10 Minshull Street and 11 Bloom Street

SCAFFOLDING OPTIONAL APPRAISAL

LISTED BUILDING CONSENT CONDITION RELEASE 5

Planning Permission 119375/LO/2018 & 119373/LO/2018

C – Combined scaffolding drawings

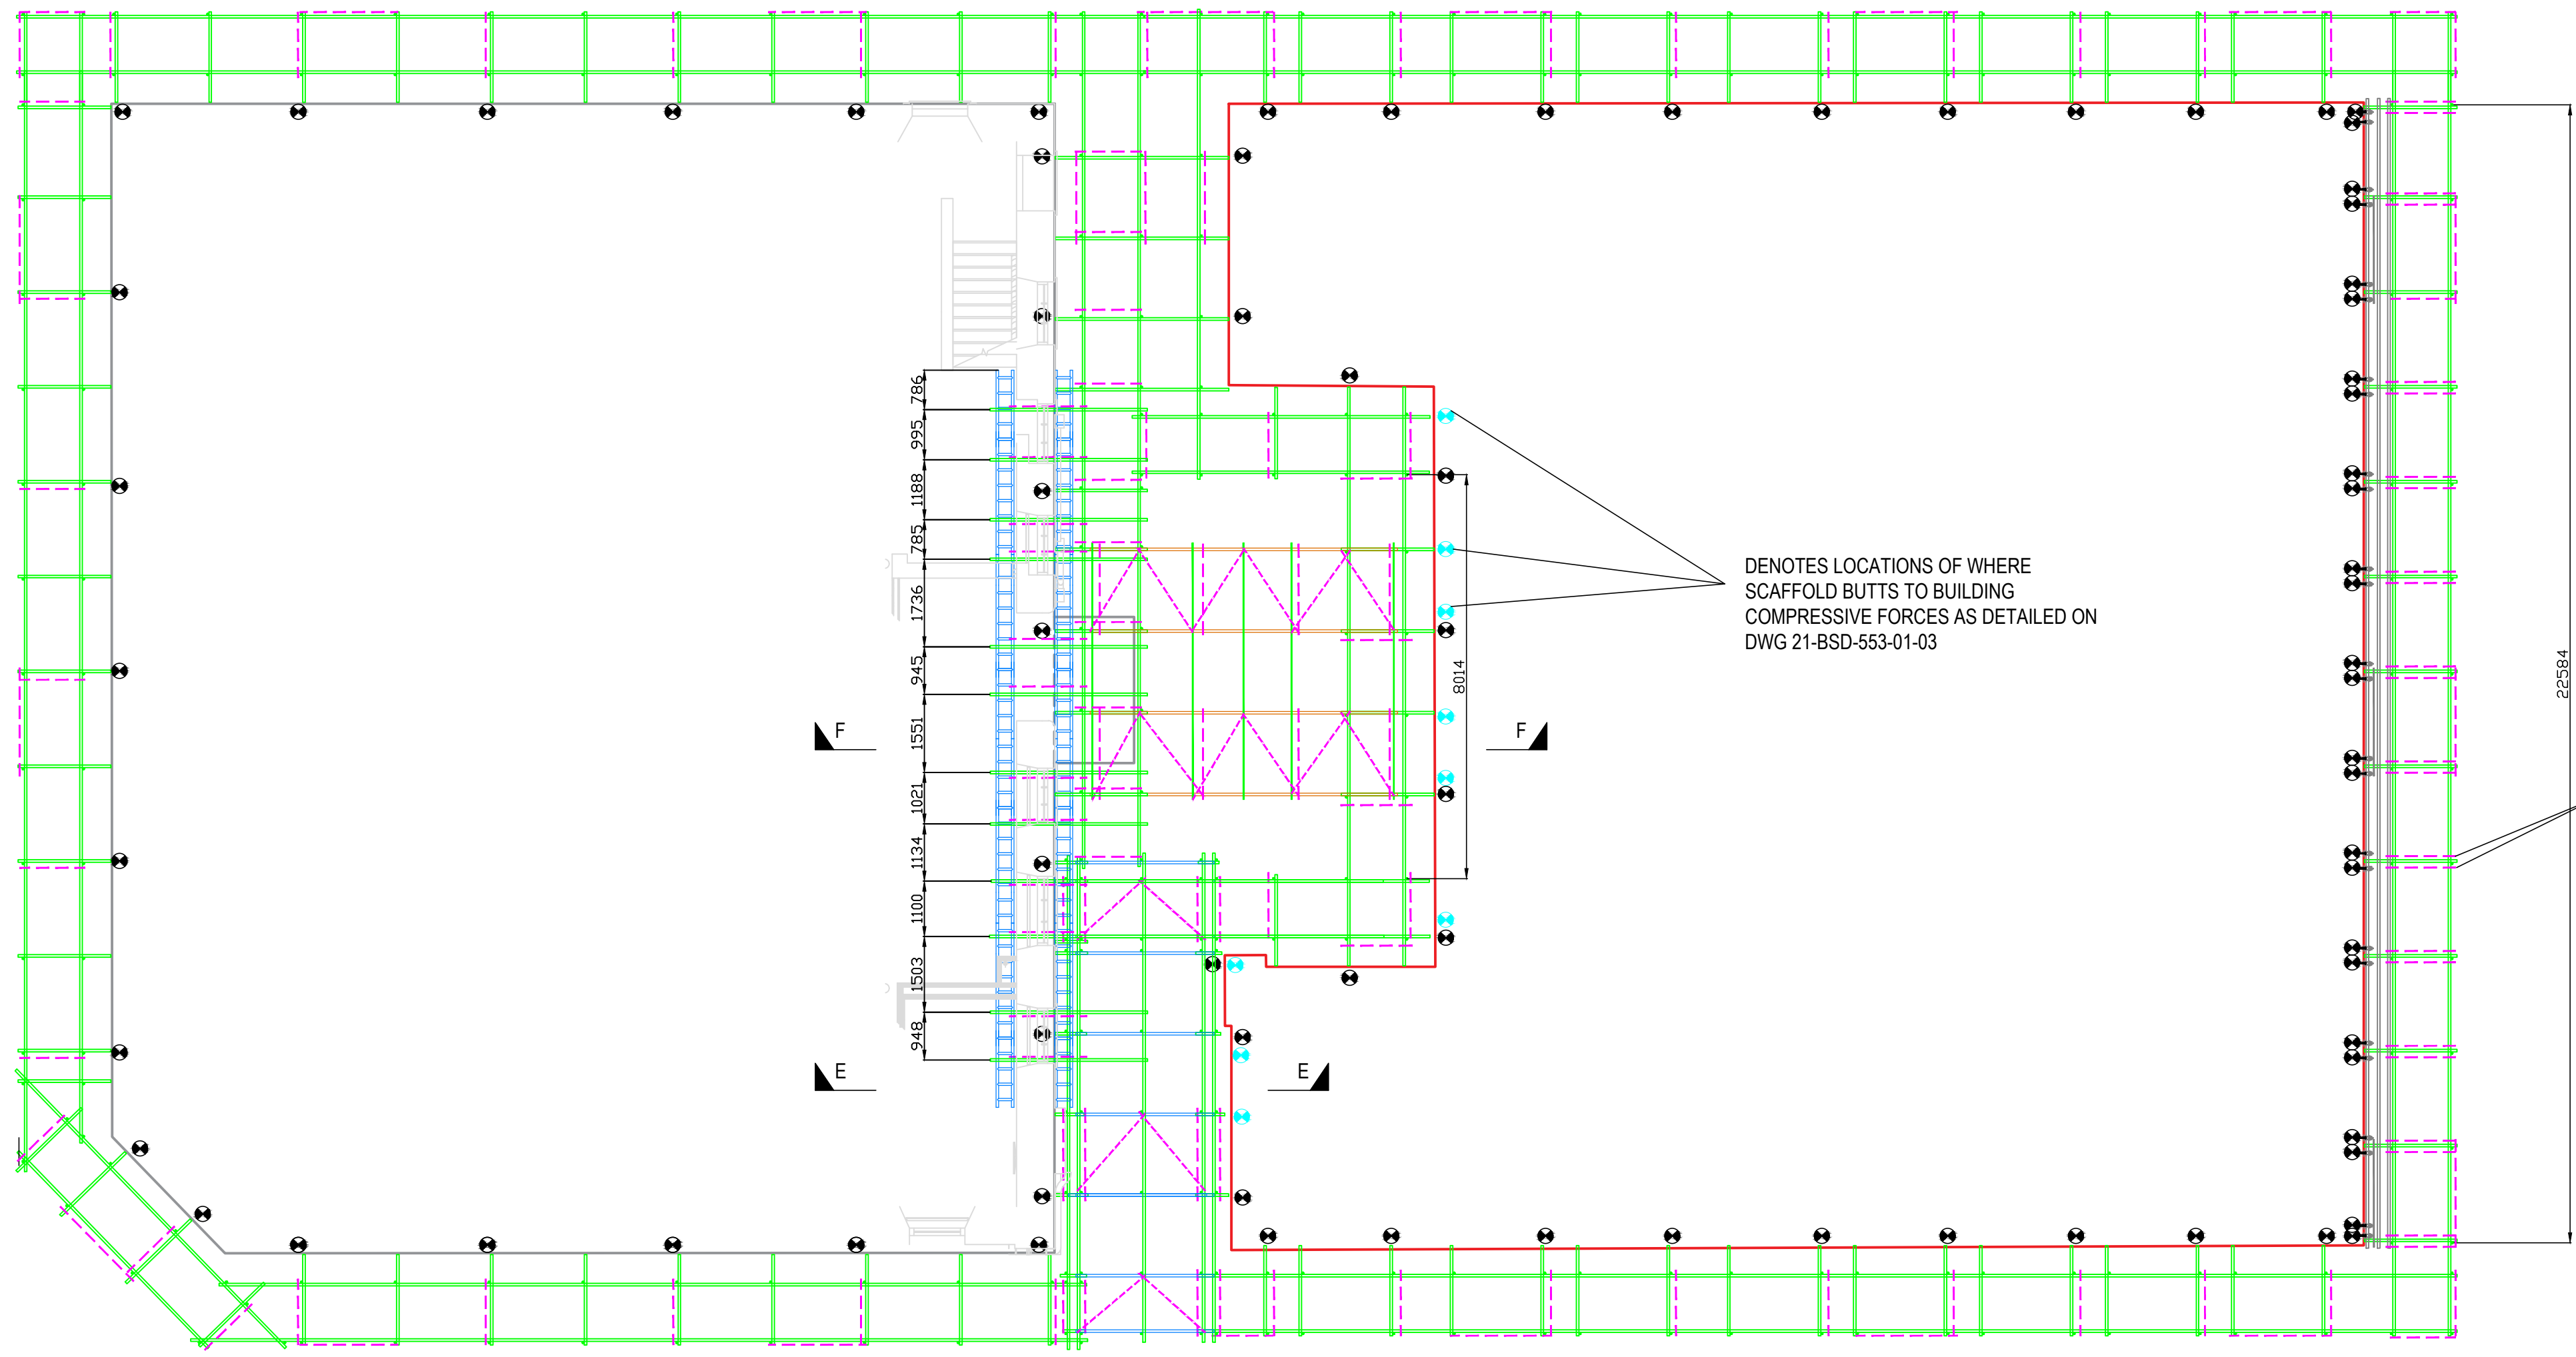
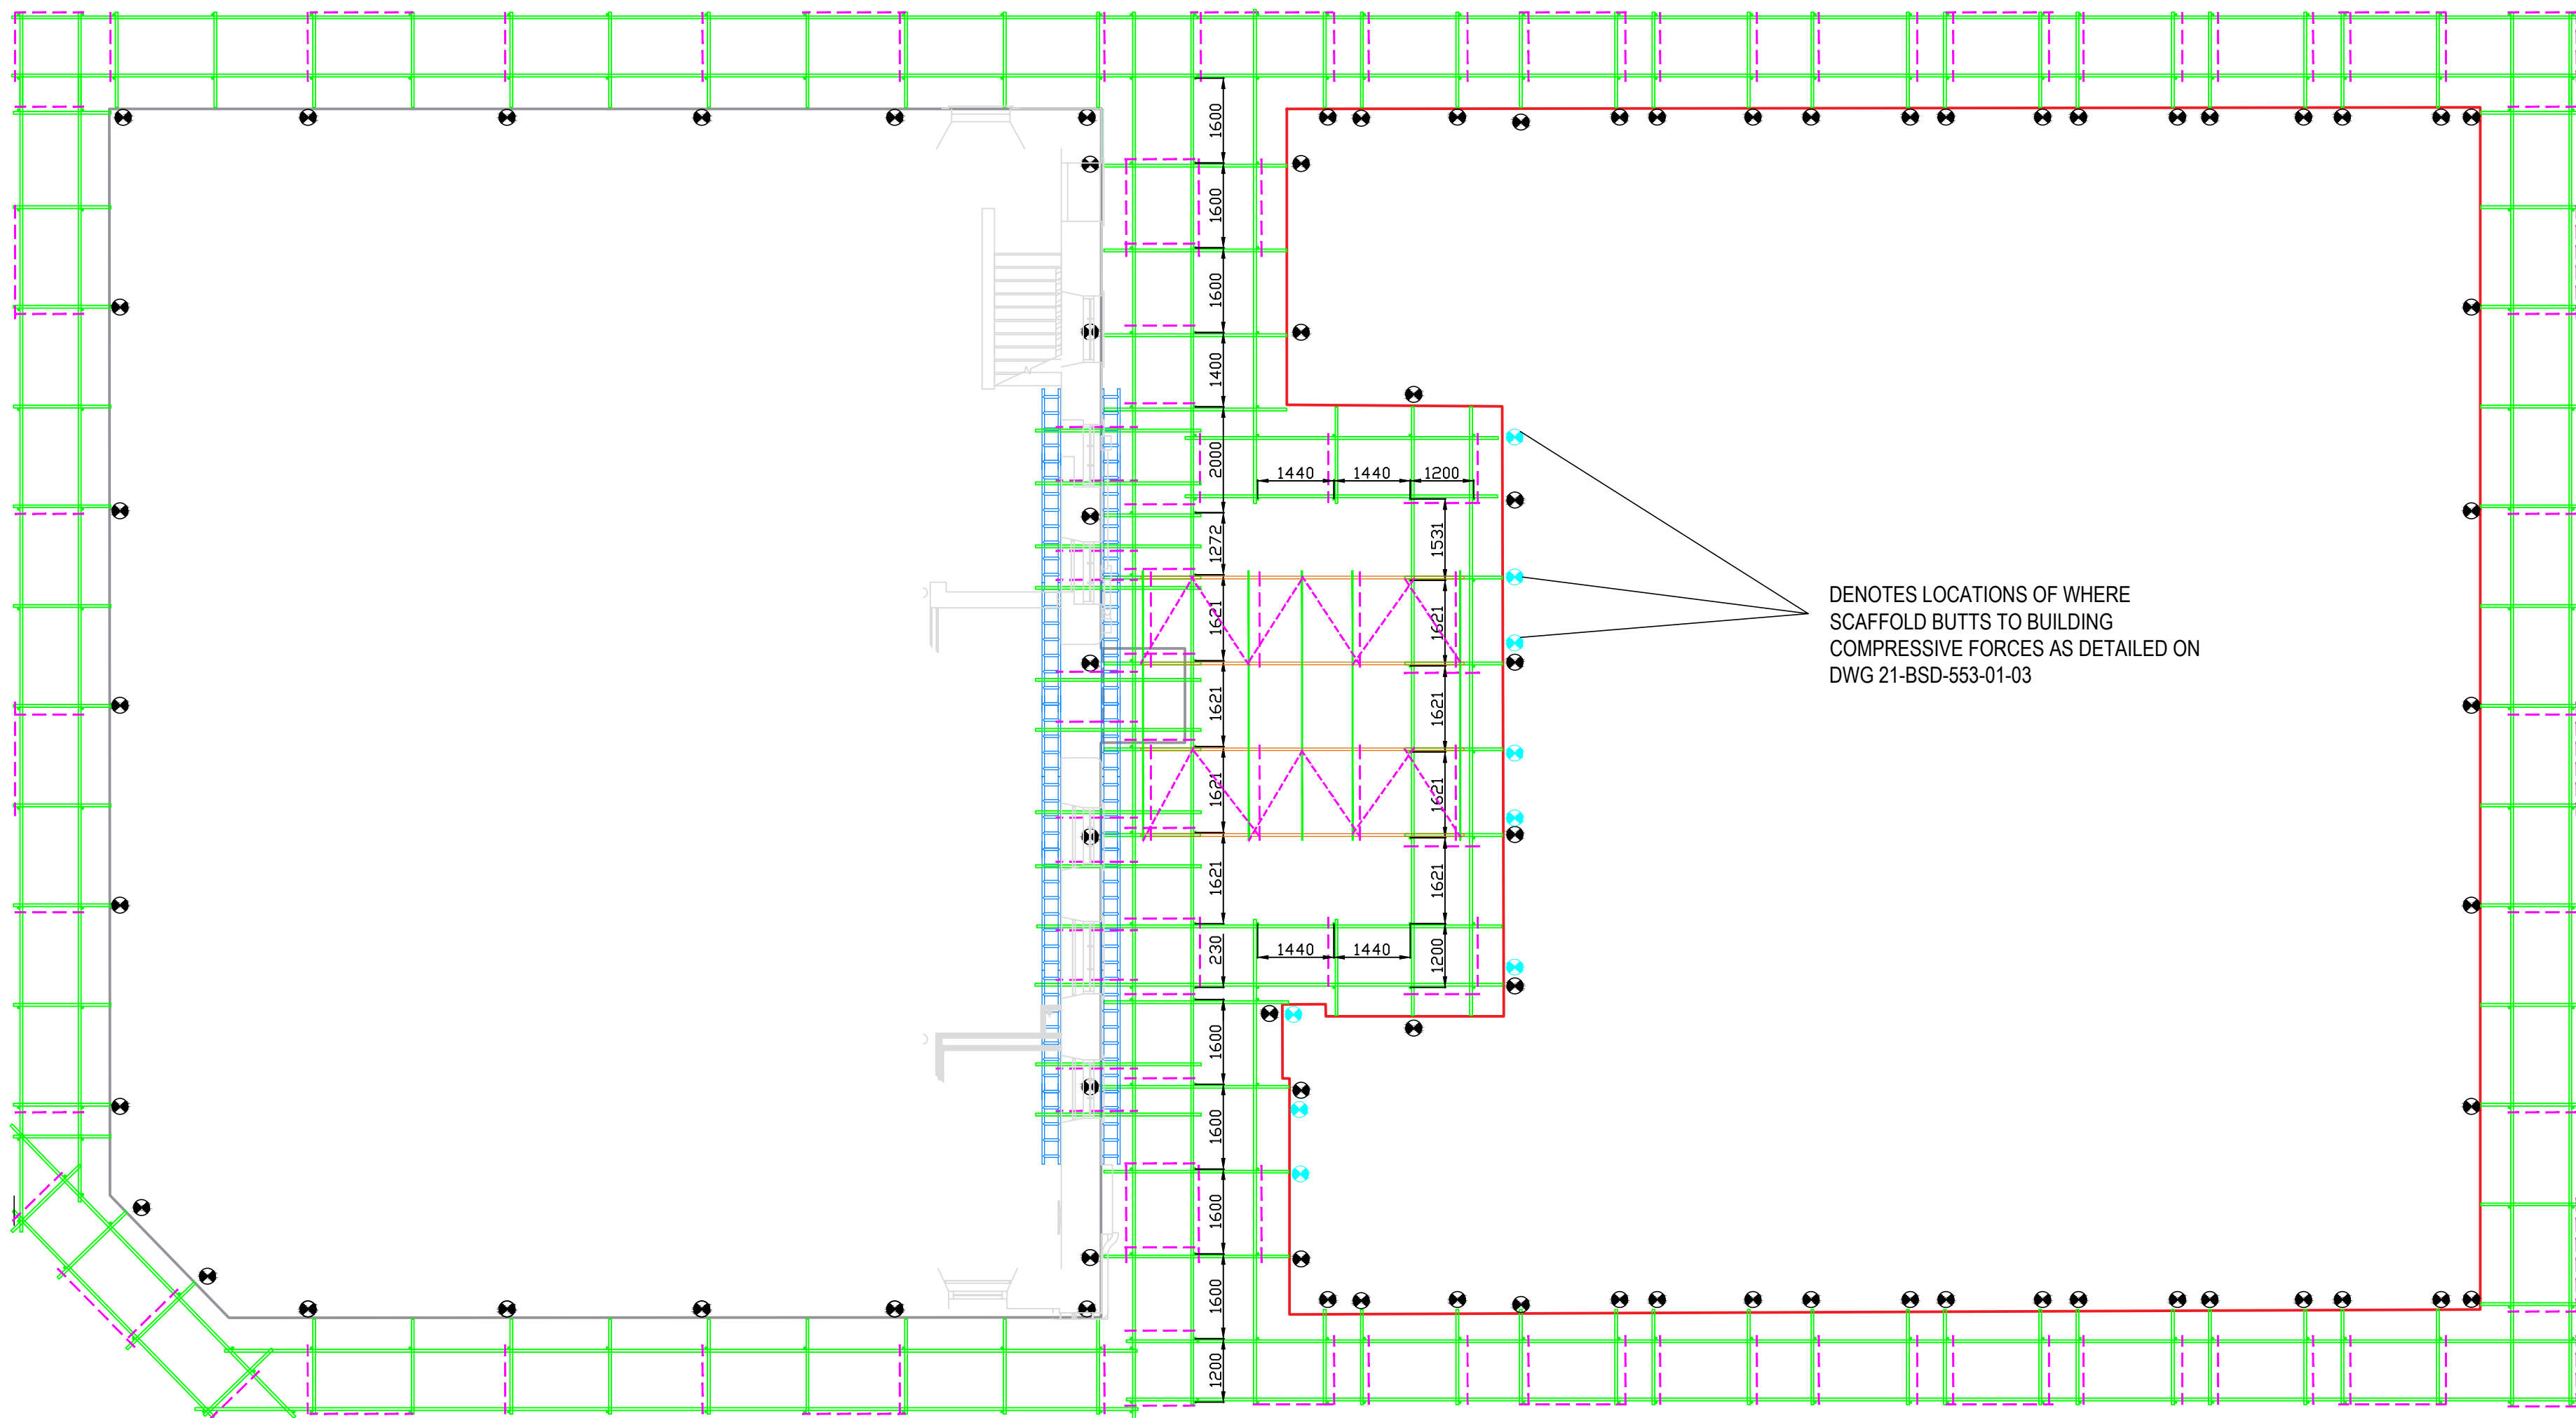
Also, it is noted that the scaffold drawings show 11 Bloom Street is to have a temporary scaffold roof covering, but not Mindel House. If a temporary roof was installed over Mindel, this would allow the roof structure to be more fully investigated from above, with the removal

Comments: refer to section (3) regarding comments on the approach to consolidating this elevation, and on the loads and the basement vaulting etc (noting the scaffold drawings ought to show the vaulted areas of basement in relation to the plan leg loads), and the possibility/benefit of a temporary roof over Mindel House as well as Bloom St.
